Addendum No. 005

**Subject: 2020 Classroom Modernizations
SDP Contract Numbers: B-007 C of 19/20 & B-009 C of 19/20**

**Location: George Sharswood School
2300 S. 2nd St, Philadelphia PA 19148**

This Addendum, dated March 06, 2020, shall modify and become part of the Contract Documents for the work of this project. Any items not mentioned herein, or affected by, shall be performed strictly in accordance with the original documents.

1 ELECTRICAL FIRST FLOOR POWER PLAN
E2.1 1/8" = 1'-0"

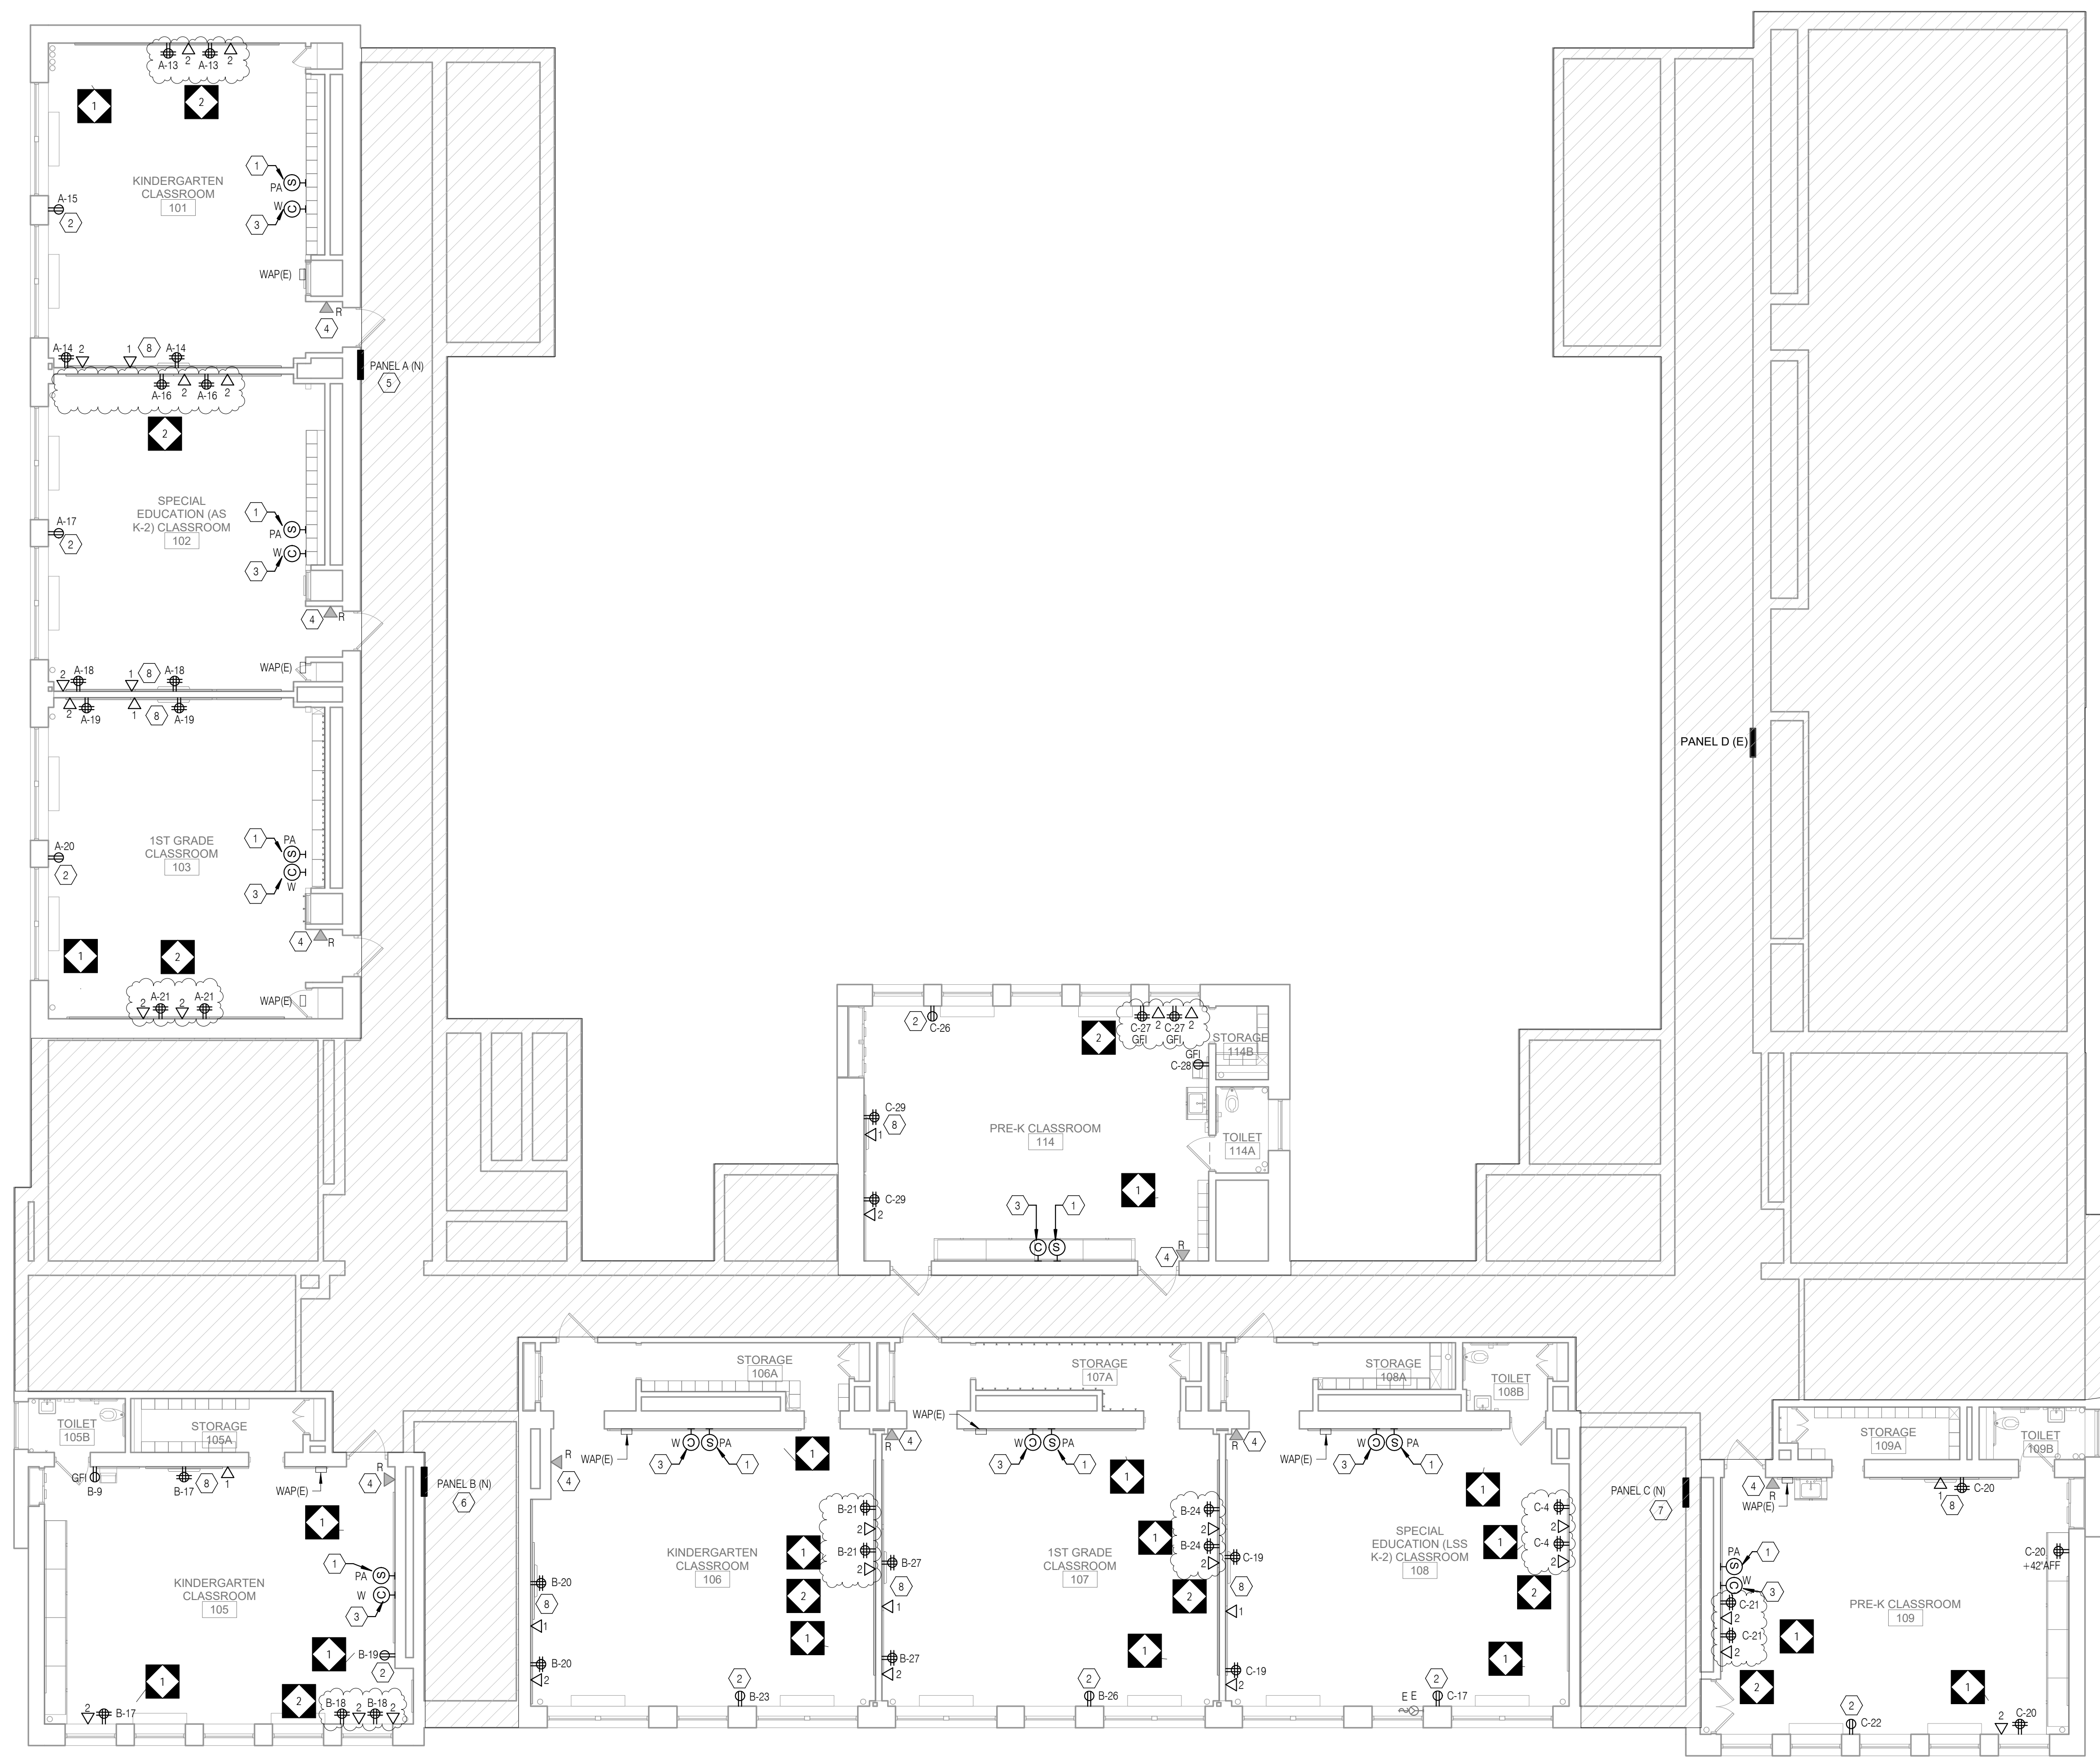
1. REVISE data outlet locations and scope as indicated on the drawings.

1 ELECTRICAL SECOND FLOOR POWER PLAN
E2.2 1/8" = 1'-0"

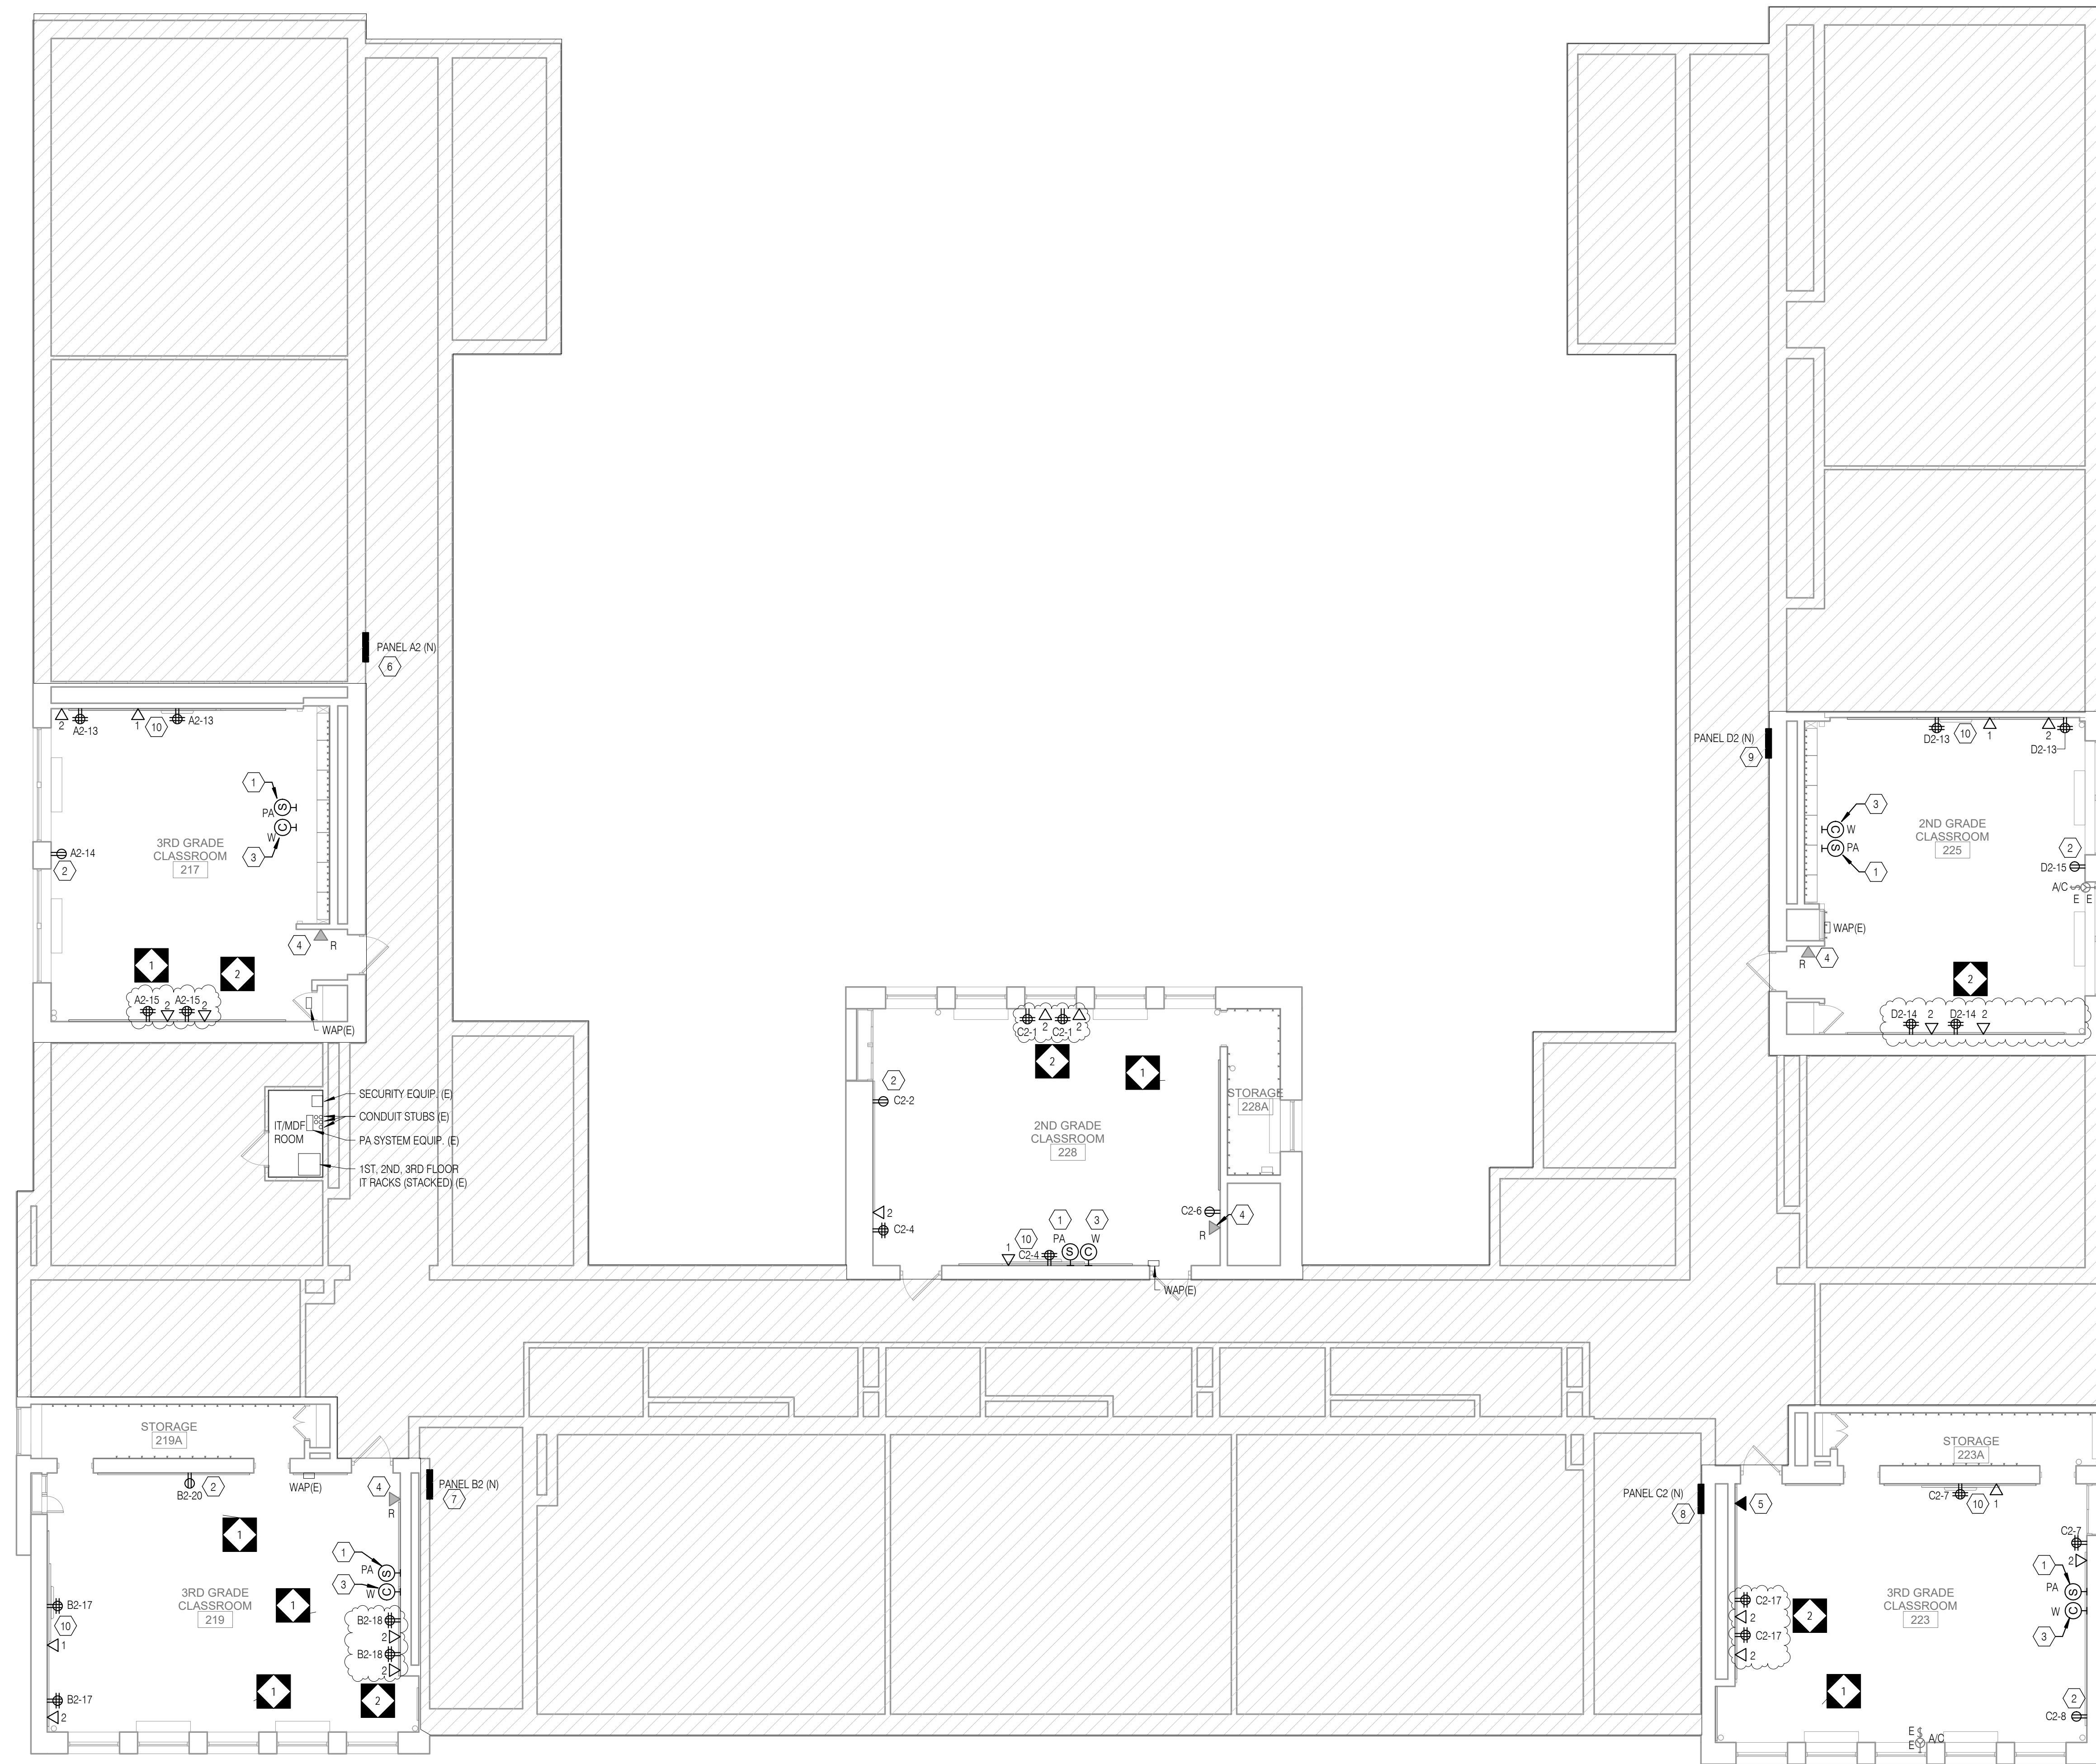
1. REVISE data outlet locations and scope as indicated on the drawings.

3 TYPICAL CLASSROOM LIGHTING CONTROLLER
E7.1 NTS

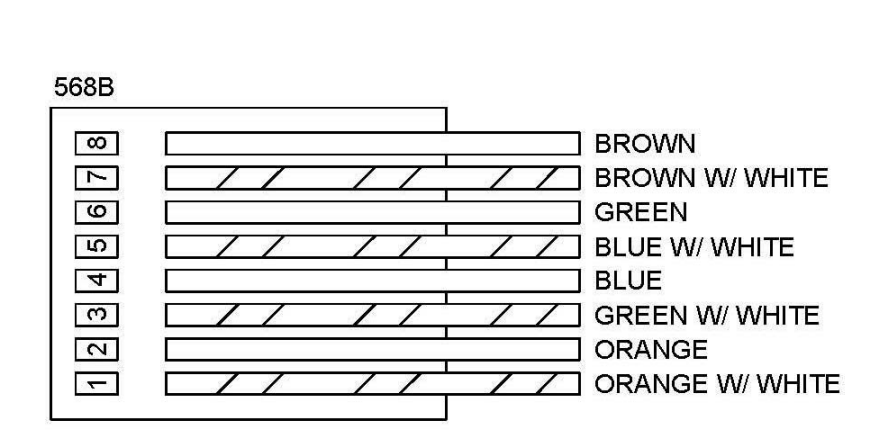
1. REVISE 3/E7.1 Typical Classroom Lighting Controller diagram as indicated on the drawings.
